Interim Drainage Report  
for  
**Windingwalk Grading**  
at  
**Meridian Ranch**

Comments provided by EN,  
2/16/18

PCD Project No. EGP-17-001

FIGURE 4

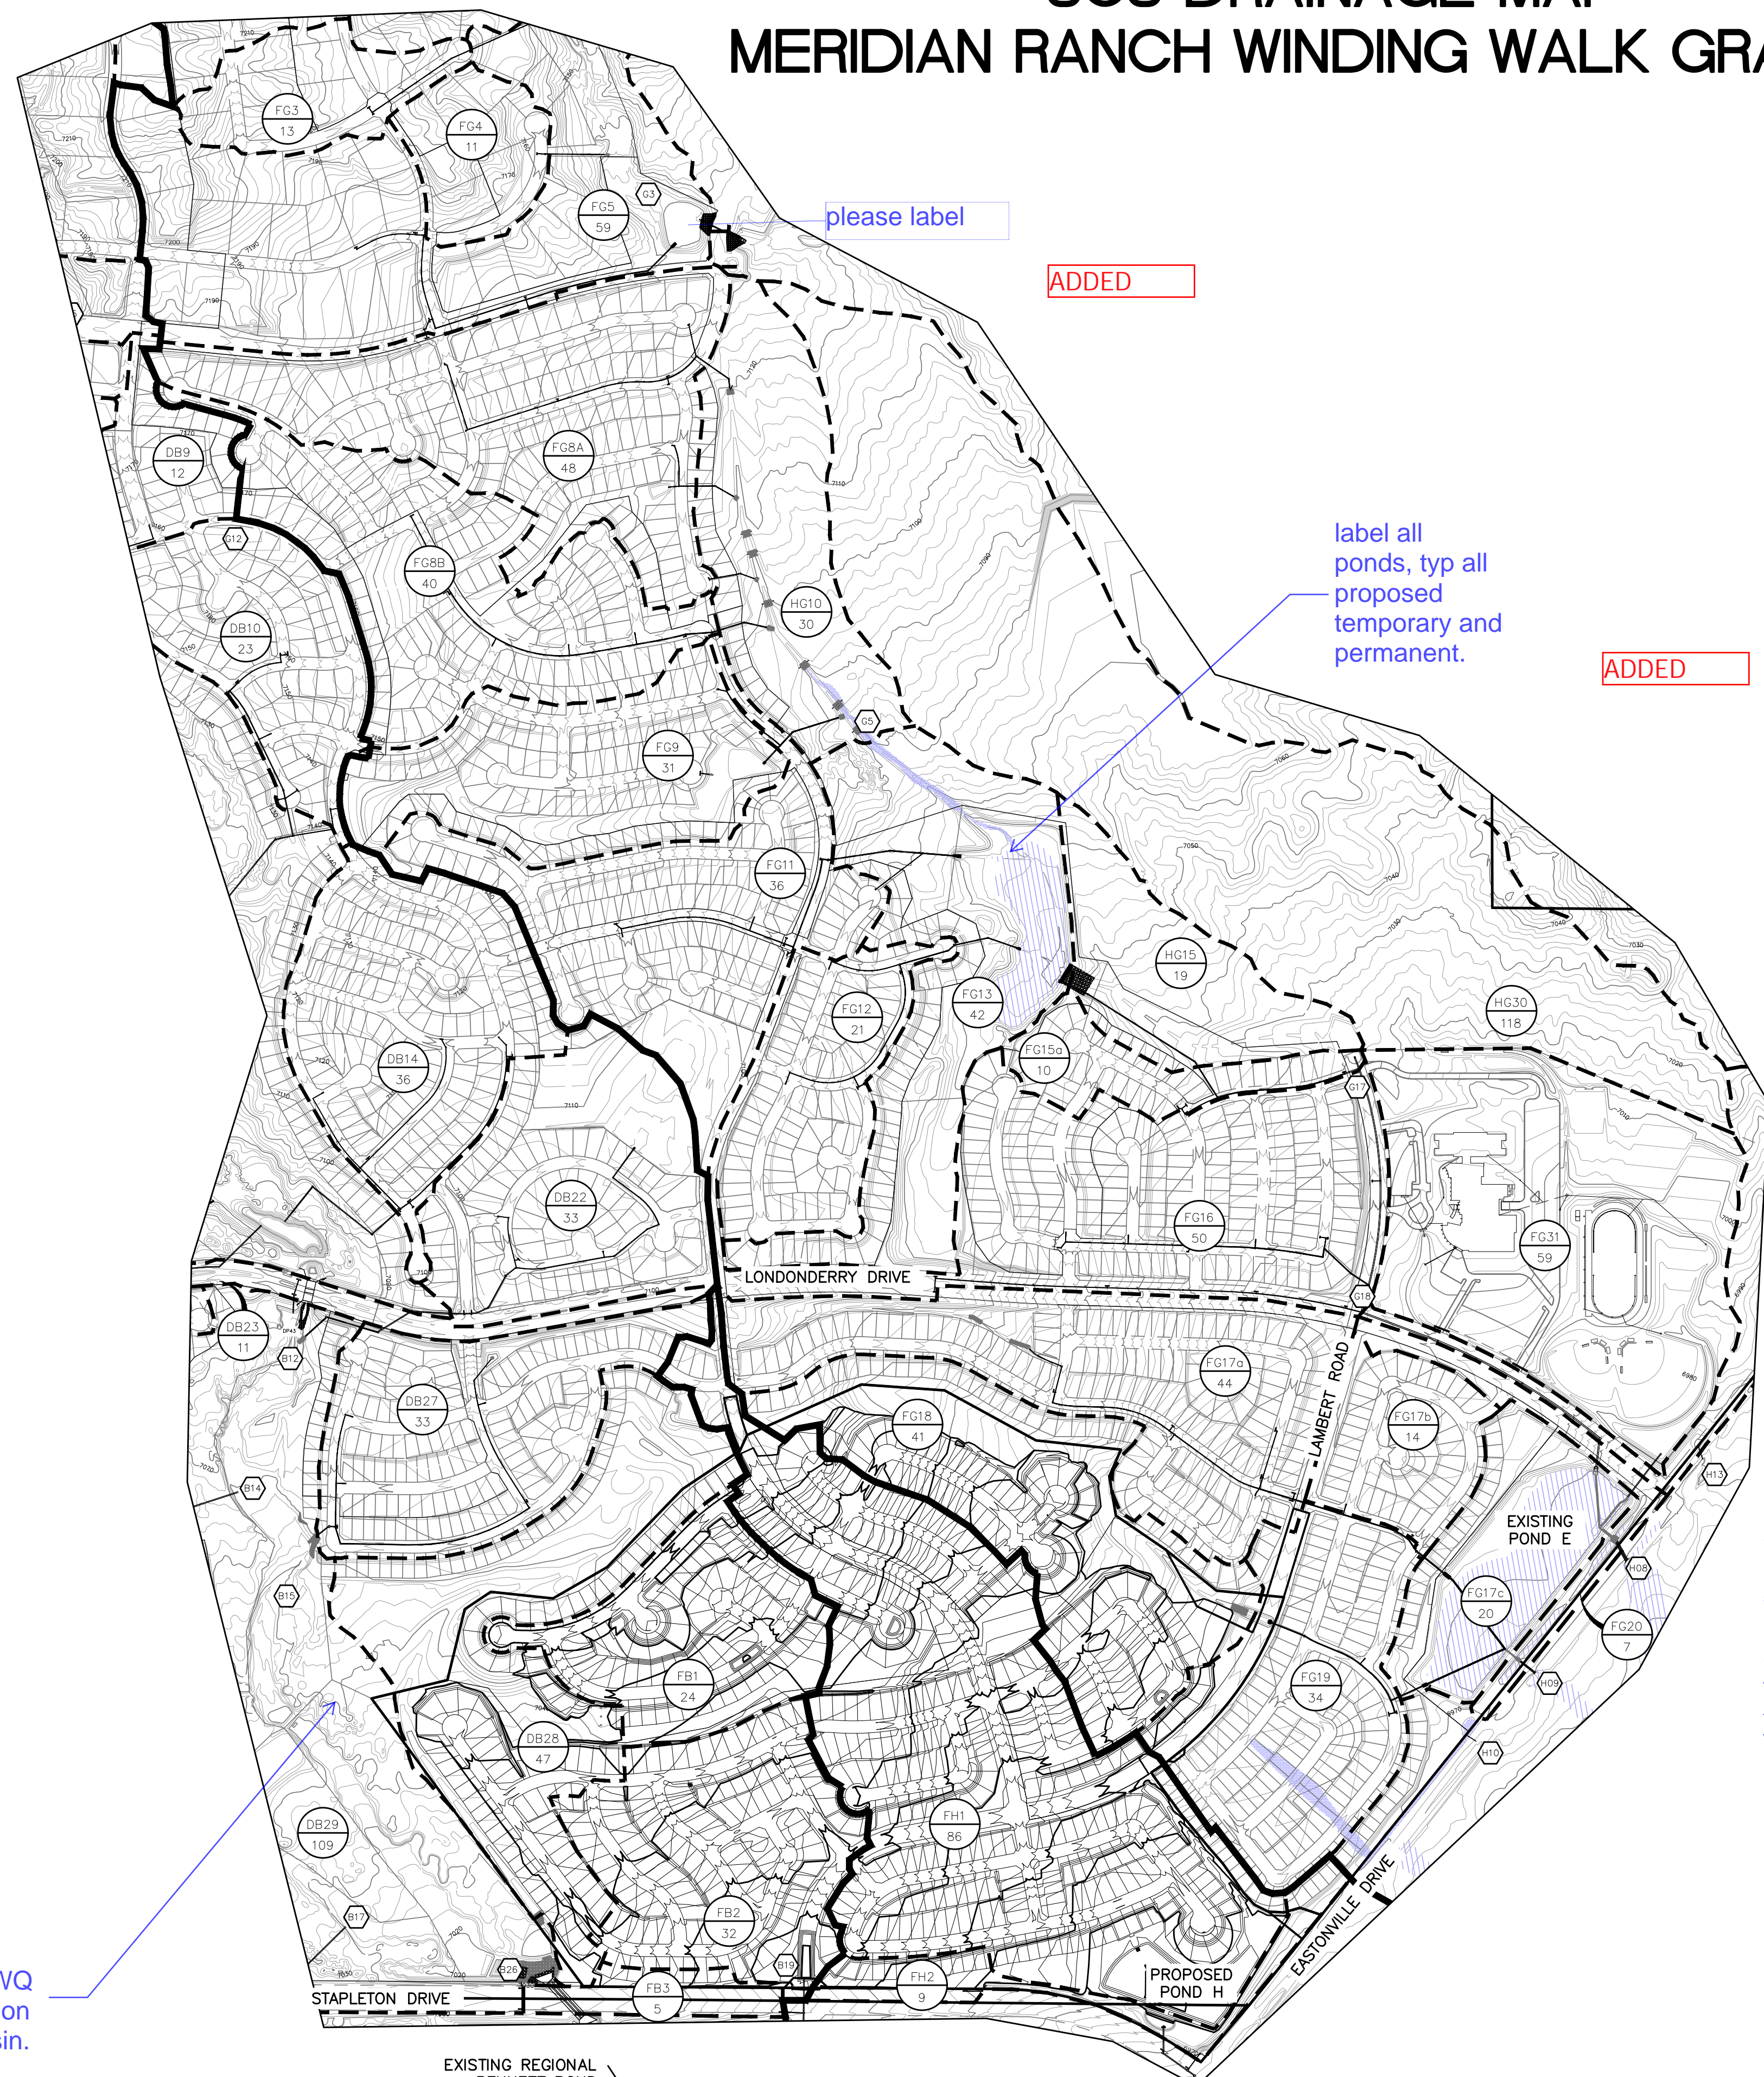
please label

Show and label the temporary sedimentation pond locations. ADDED

Include a table of tributary area draining into each temporary sediment pond and the required volume needed. ADDED

NOT RESOLVED. EACH POND (TEMP OR PERM) SHOULD BE CALLED OUT ON THIS SHEET AND LABELD AS TEMP OR PERMANENT. INCLUDE TABLE AS REQUESTED. 100 percent of the developed area must go through a permanent WQ facility prior to discharge to state waters. Please confirm this on this plan.

show proposed WQ and detention for this Basin.

ADDED

ADDED

ADDED FLOW/DP TABLE

FORGOT TO INSERT UPDATED SHEET LAST TIME
